Name: Horizon Park Subdivision - Preliminary Plan (2)

REVIEW COMMENTS - January 18, 1993

**FILE NO. #2-93 TITLE HEADING: PRELIMINARY PLAN, LOT 2 -
HORIZON PARK SUBDIVISION**

REQUEST: Preliminary Plan--Horizon Park Subdivision

FLOOR PLAN - preliminary design - OPTION 'B'
 1/4" = 1'-0"

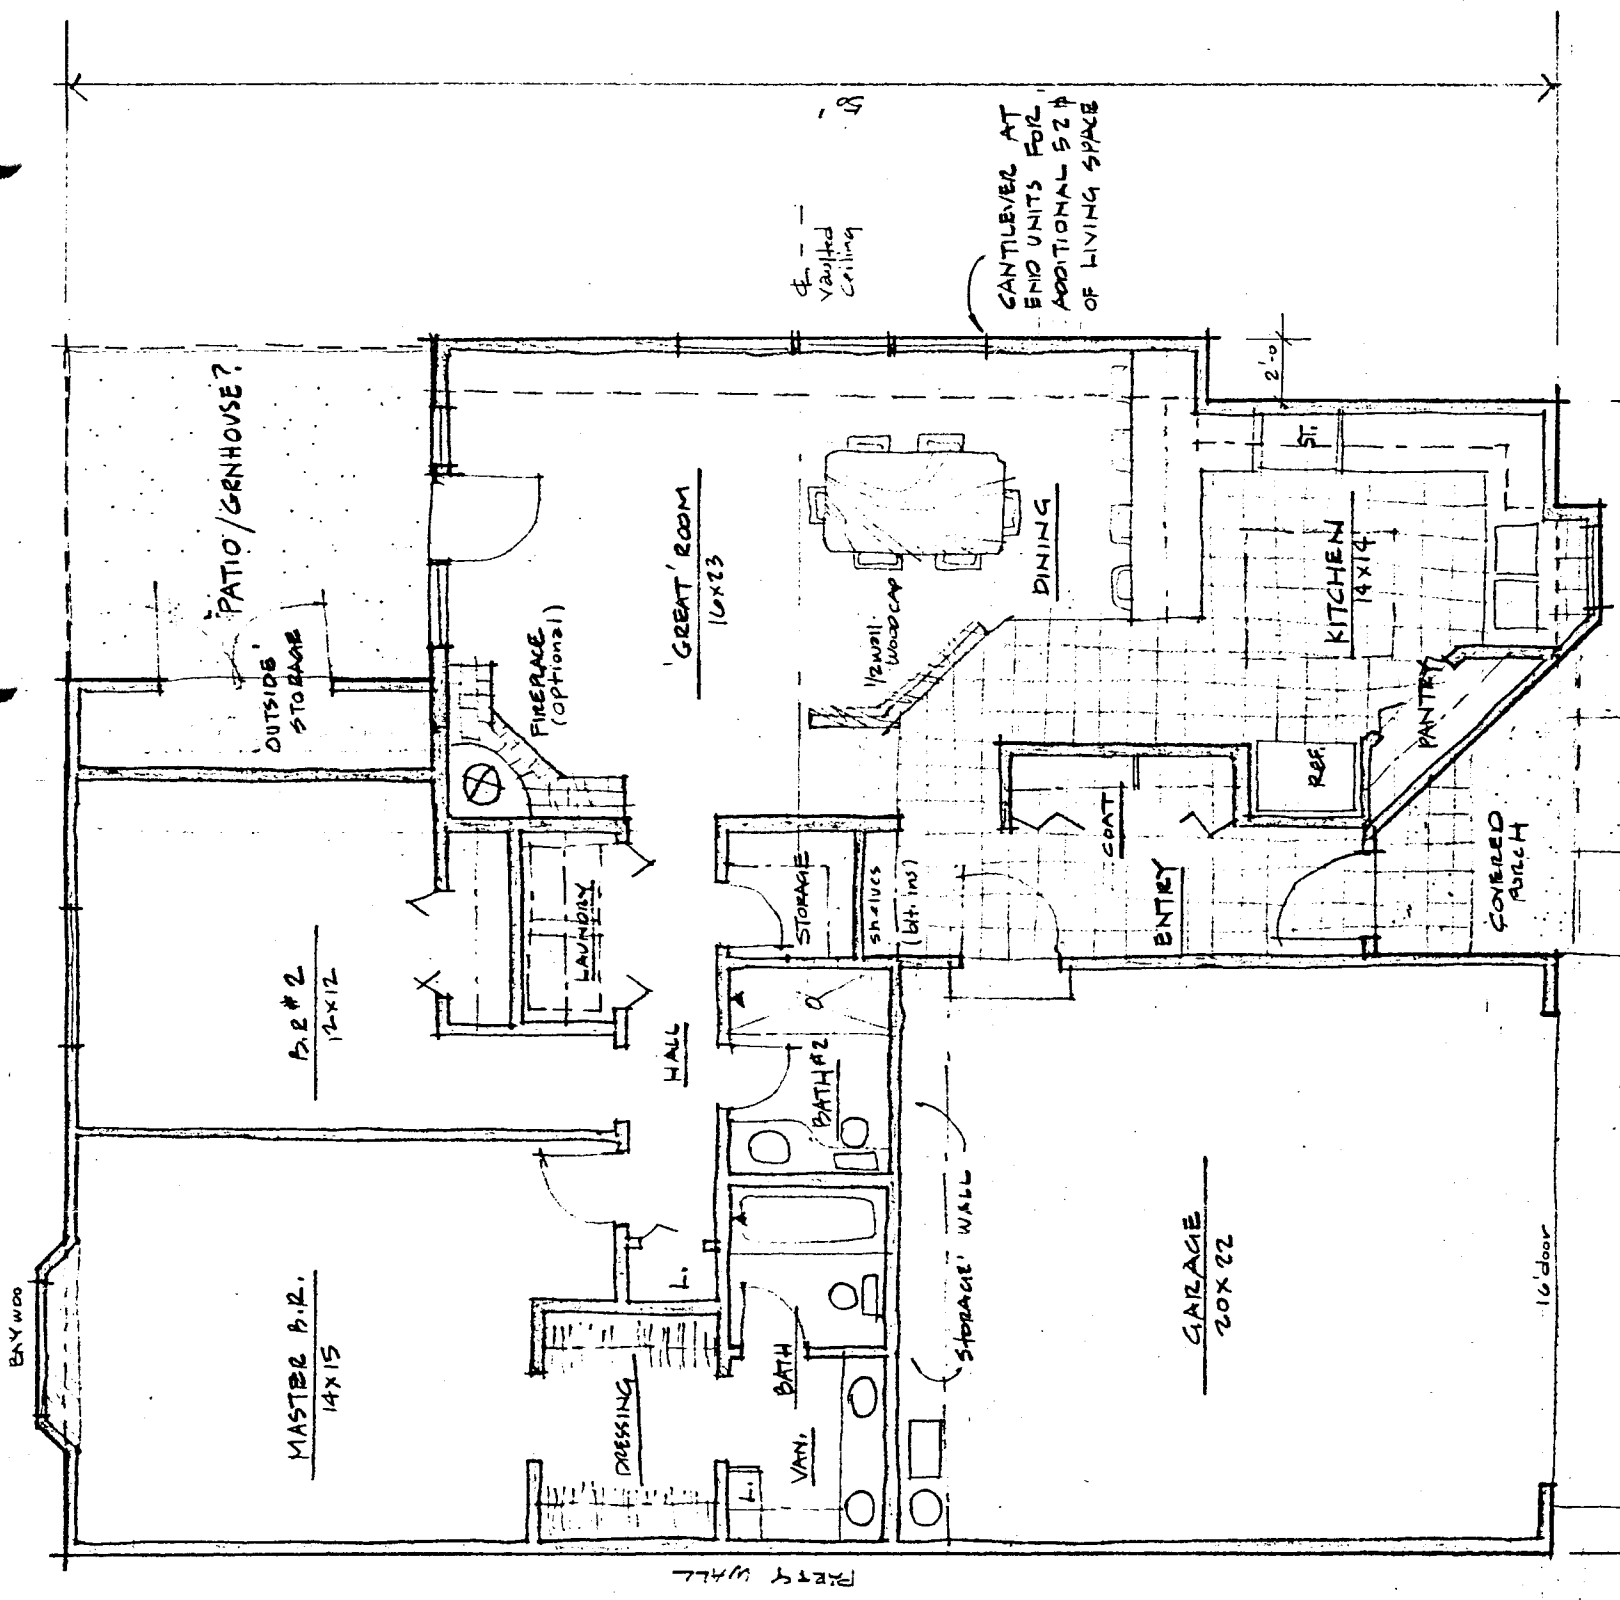
6. A typical elevation and/or perspective drawing is required for the attached units (section 7-5-4.B.3).
7. If phasing is proposed it must be indicated on the site plan and in the narrative.

6. Aesthetics: See attached drawing for 'prototype' of proposed units. Single level two- and three-bedroom units are planned.
7. Phasing: Entrance 'A' shown on the Plan serves 'Phase A' and Entrance 'B' serves 'Phase B.' It is anticipated that 'Phase A', north of the Wetlands area, will be constructed first. The roadway will be extended to the 90° turn in the road where a cul-de-sac will be maintained until the south portion of 'Phase A' is completed.

SITE PLAN AND UNIT LAYOUT, PRELIMINARY

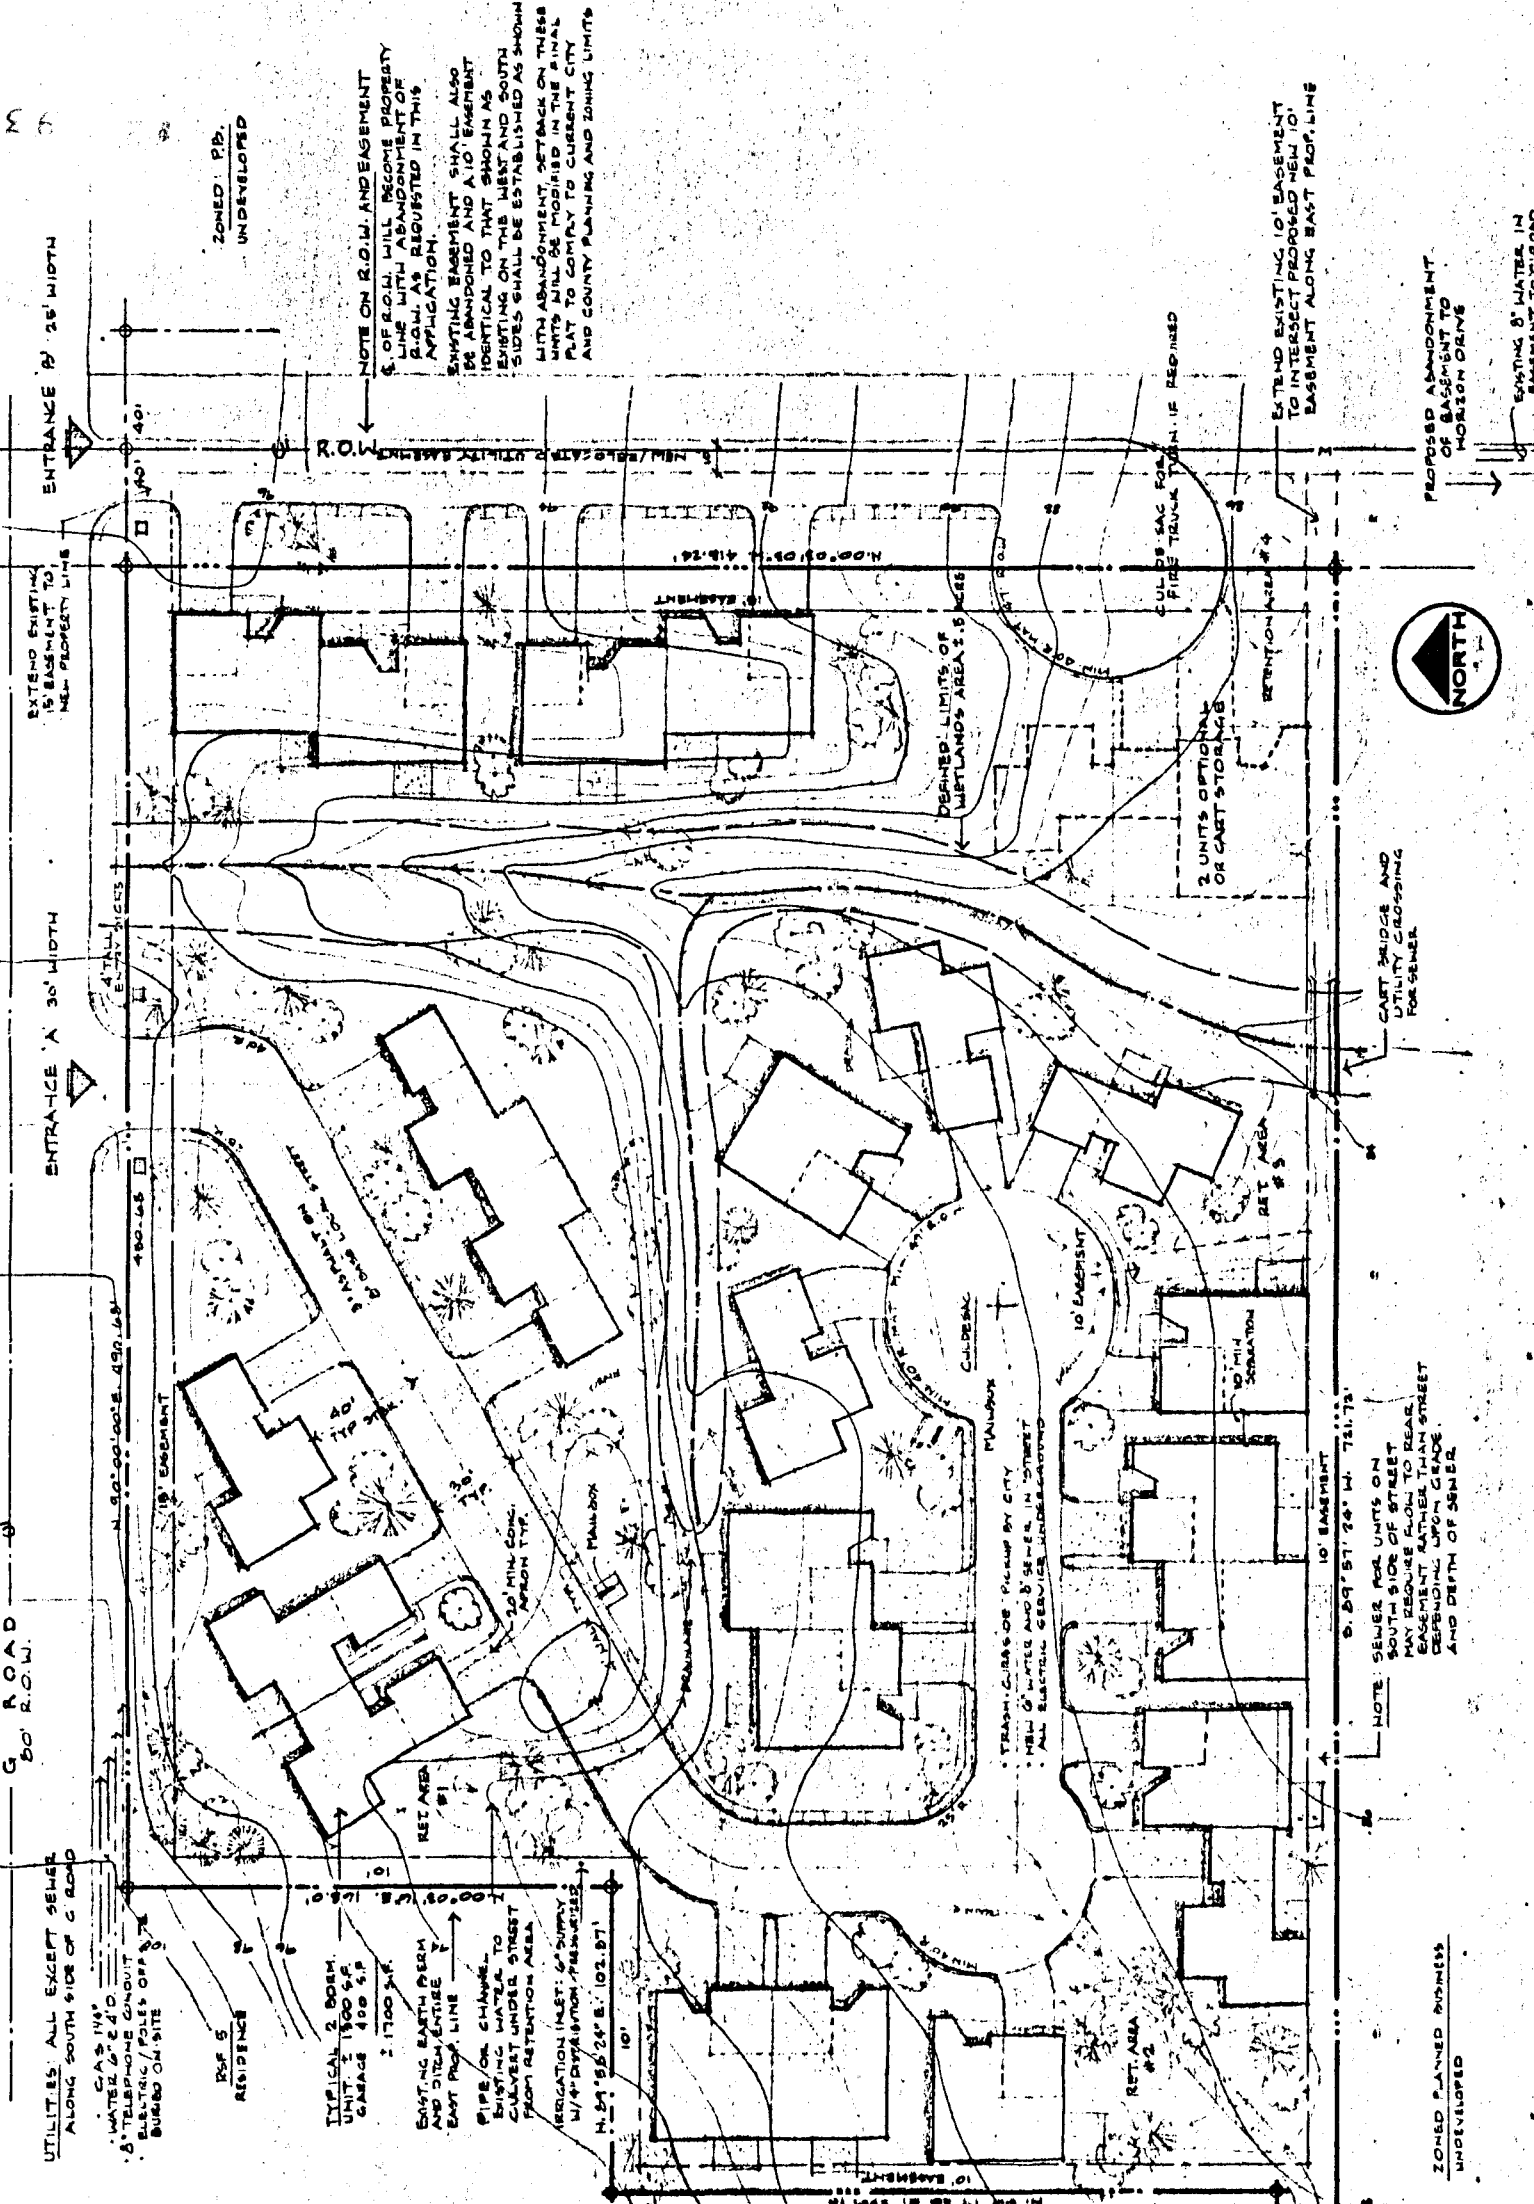
Not all the items on the action sheet were submitted for review, and much of what was submitted is incomplete and unacceptable (see the attached checklist with references to the Development Code). Notwithstanding, a brief cursory review of the plan was made with comments red-lined thereon.

1. The roadway geometry does not meet minimum standards and may require substantial redesign of the plan (see Development Engineer comments).
2. The street ROW for the extension of 15th Street must be retained as a public ROW and built to City standards. However, the abandonment of the ROW to the south of the property would make sense.

1. Roadway: Front entrance and lower radius will be revised to comply to minimum standards as required by City/County standards for Final Plat. Minor adjustments in unit locations may be required in the Final Plat.

2. Any roadway on the property will be constructed to County standards and certified by the Petitioner's engineer. The Petitioner does not wish to extend a roadway to the south of the property to connect to Horizon Drive. Petitioner wishes to revise Request for Abandonment to a Reduction of R.O.W. from Minor Arterial to Commercial Street Section (from 40' R.O.W. to 26' R.O.W.).
